ITASCA DOCUMENT REVIEW

File No.: 006-01-55

Document Title: "Technical Basis for Performance Goals, Design Requirements and Material Recommendations for the NNWSI Repository Sealing Program" by Joseph A. Fernandez, Peter C. Kelsall, John B. Case, and Dann Meyer (SAND84-1895, September 1987)

Reviewer: Itasca Consulting Group, Inc.
(J. Daemen, K. Wahi and L. Lorig)

[Standard Handbook for Mechanical Engineers, p. 3-51]

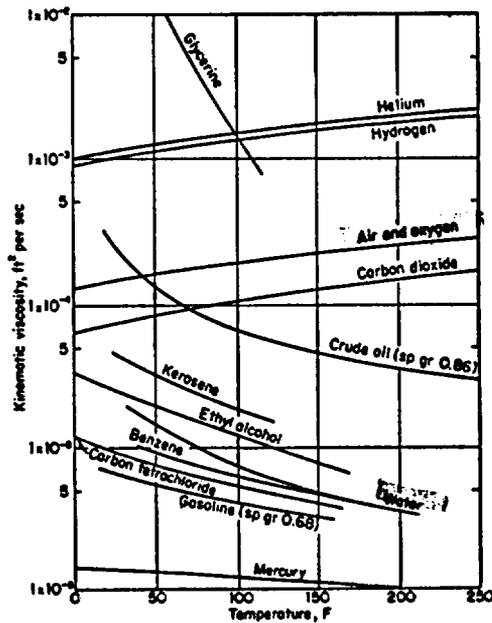
The air conductivity values assumed are a constant fraction (1/20) of the corresponding hydraulic conductivity values. Presumably, a relationship given by Freeze and Cherry (1979) has been used. An air-to-water kinematic viscosity (i.e., the factor μ/ρ) ratio of 20 is, therefore, implied. This ratio is not constant. At least one order of magnitude variation in this ratio can be expected in the temperature range of 50°F to 250°F. (See figure, below, from the Standard Handbook for Mechanical Engineers.)
